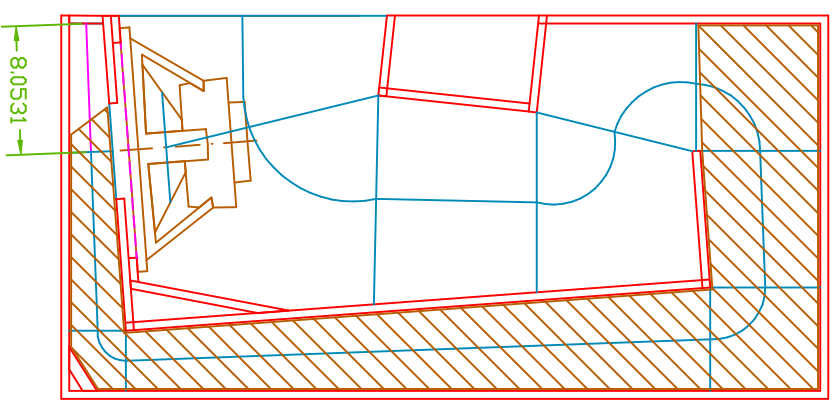
As drawn the speaker vents through a throat chamber into a 29" wide horn slot. Another possibility would be venting into a horn slot that widens from the speaker to meet the 29" width at the first right angle box corner from the throat. Obviously, it would be easiest to have the speaker coupled to the horn through a full sized circular opening, e.g.: about 14"Dia. for the 401SLF. From the simulations, the throat chamber volume and cross-sectional area affect the impulse response quite drastically. Just from bad past experiences, the 1/2" material should be very well cross-braced and stiffened (or replaced w/ 3/4"). The woodworking ist made easier by keeping the horn wall sections at 90° angles with each other. The woofer mounting should be doubled and stiffened as shown.
